STAFF REPORT ADDENDUM

APPLICATION RZ/FDP 1998-PR-026

CONCEPTUAL DEVELOPMENT PLAN
FINAL DEVELOPMENT PLAN
(CDP/FDP)

MORGAN CHASE

SHEET	4
OF	10
FILE No	MISC-1007

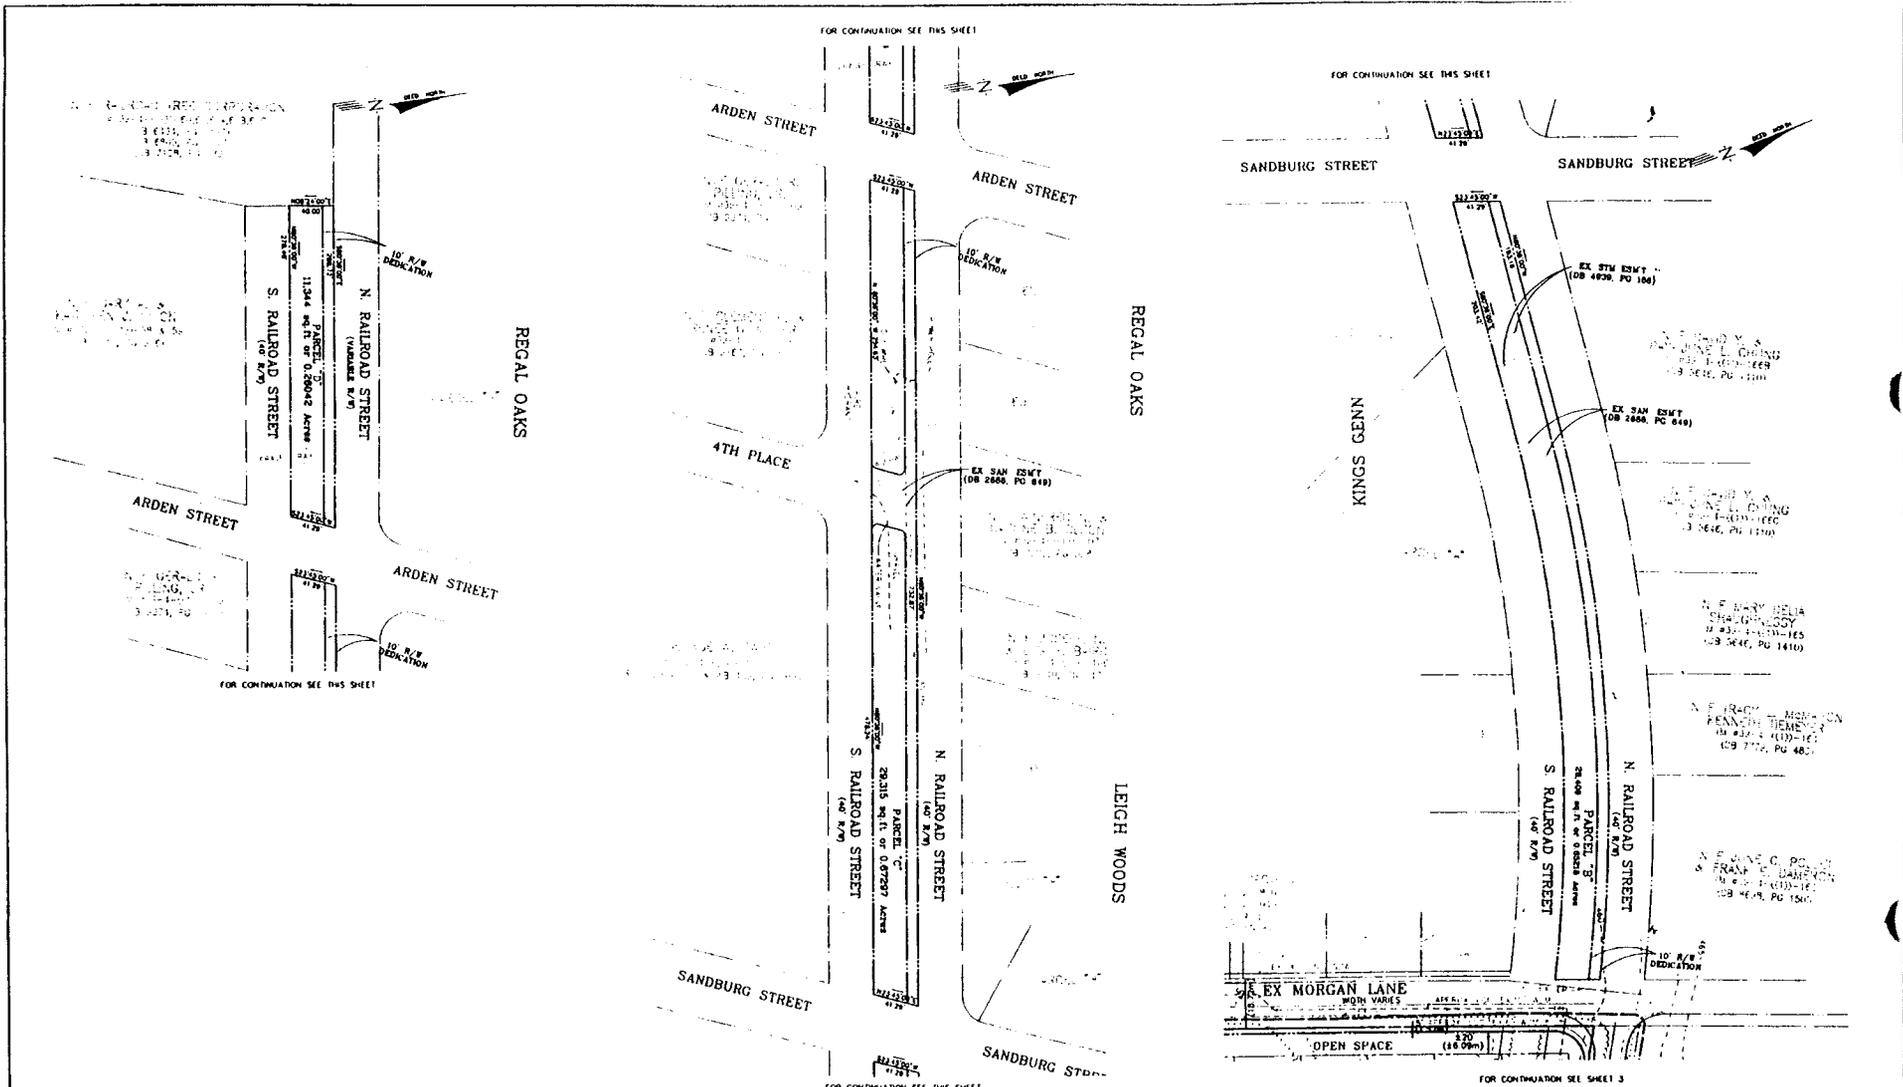
Two (2) SWM/BMP facilities are provided on the southern portion of the site. Previously, one SWM/BMP facility was proposed for the southwestern corner of the site. In order to accommodate the revised site layout and the drainage divide that exists on site, the applicant had to split the proposed facility into two. **The elimination of Lots 14-16 may allow the applicant to return to a single SWM/BMP facility design. In this way, more usable open space (and tree save) can be provided.**

the I-495 widening. ***Staff is concerned that portions of the SWM facility may encroach into the proposed reservation/dedication area. Staff proposes a new development condition, which requires that no SWM/BMP facility be located within the dedication area.***

Issue: Holmes Run is located just off the southwest corner of this site. A portion of the Holmes Run EQC extends onto this site where the development plan shows clearing and grading for a stormwater management pond. The EQC should be preserved in an undisturbed state on site.

Access to, and a portion of proposed lots 14, 15, and 16 are on steep slopes greater than 15%. The development plan should be revised to show this portion of the tract as part of the planned tree preservation area for the site.

Recommendation: Redesign the lot configuration and SWM/BMP ponds to provide a tree save area or areas in the southern one-third of the site. The entire area that now includes the proposed SWM/BMP ponds, and proposed lots 13 to 19, should be redesigned to provide a large contiguous tree save area. The elimination of lots 13 to 19 would allow for the preservation of the high quality forest and steep slopes in the southern one-third of the site. The SWM/BMP ponds could be redesigned to provide one pond that meets the requirements for honoring the drainage divides on the site.

Recommendation: Provide an expanded, contiguous tree save area along the eastern property line by redesigning to eliminate the two large proposed cul-de-sacs. The area shown as a "possible tree save area" should be included in this contiguous tree save area.

MORGAN CHASE
 Rear Elevations On Morgan Lane

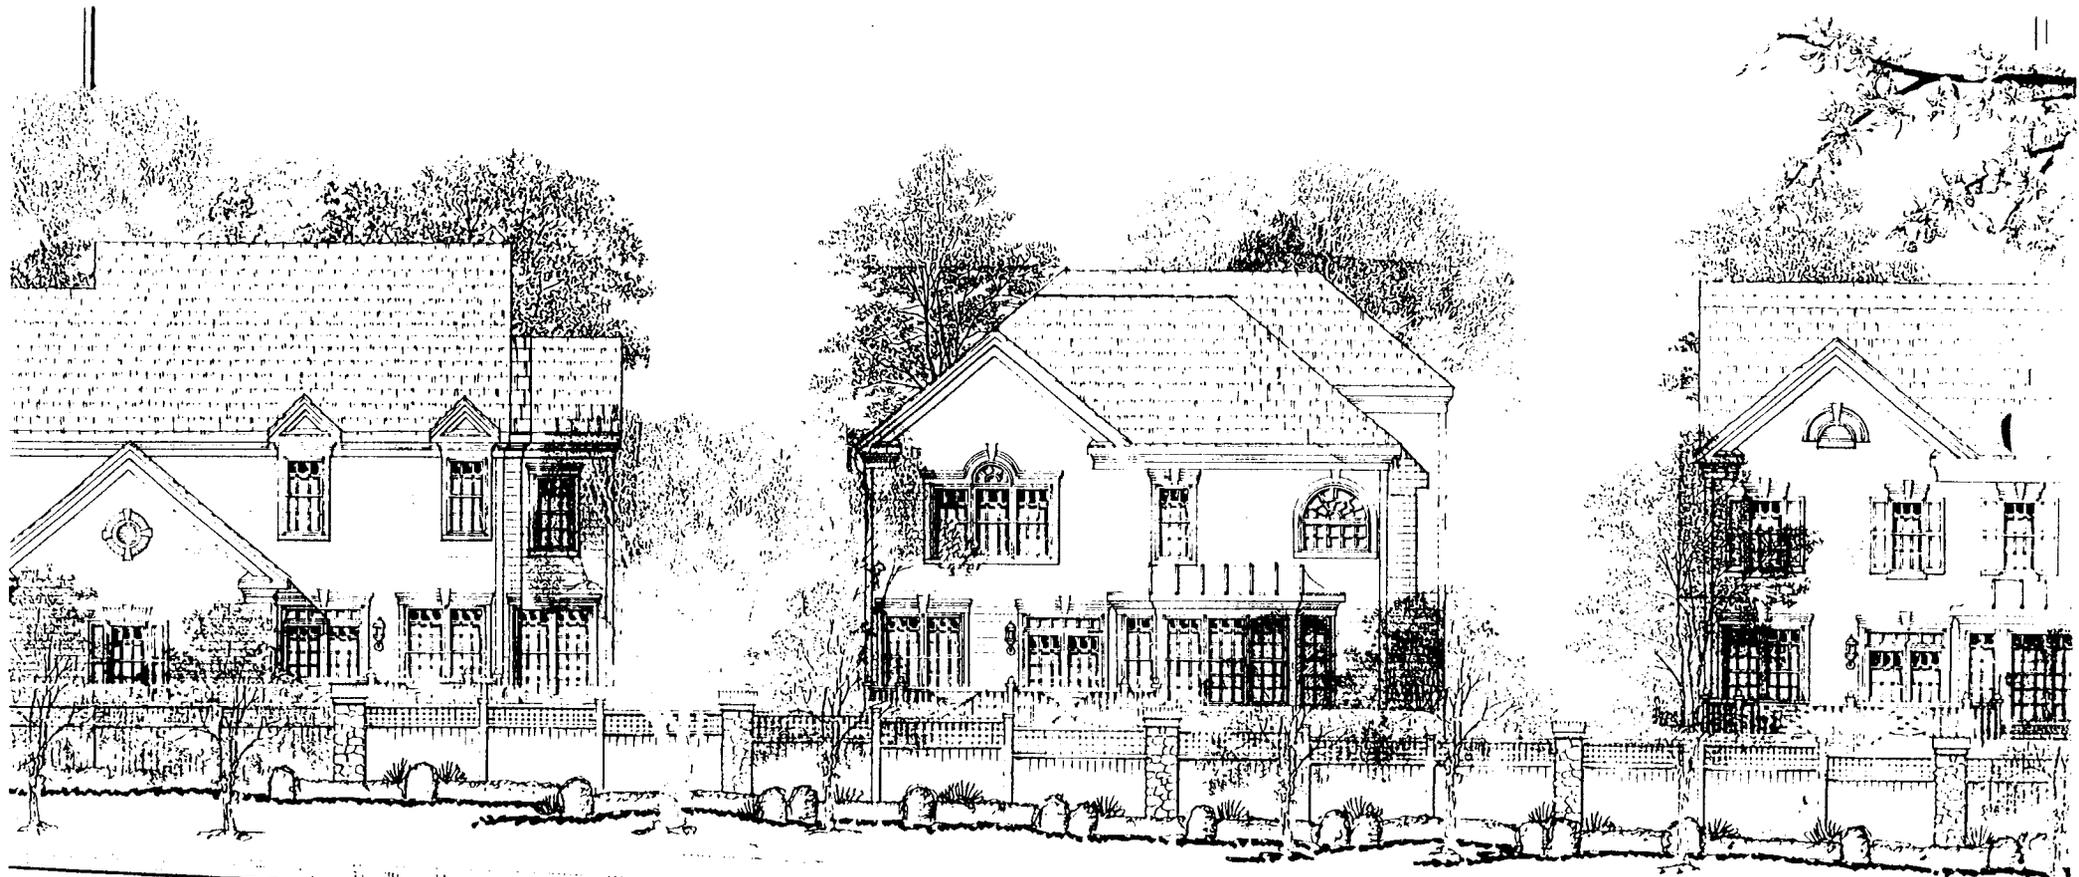
Thirteen (13) homes back to Morgan Lane (Lots 1-13). Previously, only twelve (12) homes backed up to Morgan Lane. The applicant is still committing to the architectural details of these homes' rear elevations (see Sheet 10 of the CDP/FDP) in order to address compatibility issues between the proposed development and the existing King's Glen subdivision, located to the west. Three (3) homes back to a proposed SWM/BMP facility (Lots 14-16). **Staff is concerned about the location of Lots 14 through 16. These lots are located in areas with steep slopes greater than 15%. In addition, this area includes the highest quality forest on the site. The elimination of these lots would protect these slopes and provide quality tree save.**
